TENEMENT HOUSE DEPARTMENT OF THE CITY OF NEW YORK

APPLICATION TO REPAIR

ALT. APPLICATION No. 2944 1914

LOCATION S. side of E. 14th Street. 230'-0" E. of 3rd Avenue. #220.

PLAN OF STOREFRONT

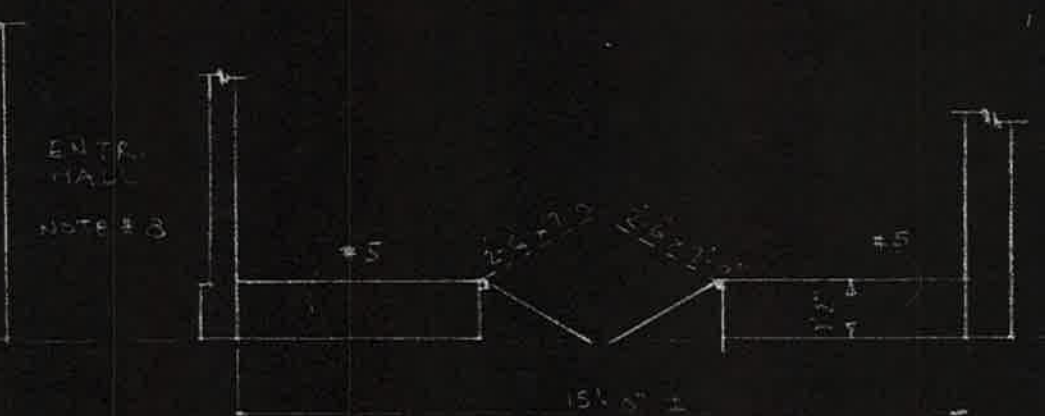
State proposed work in detail: Alter storefront to layout indicated.

This building notice has been examined only for the work shown. The discrepancies stated have not been verified nor approved. AD 6 5-51
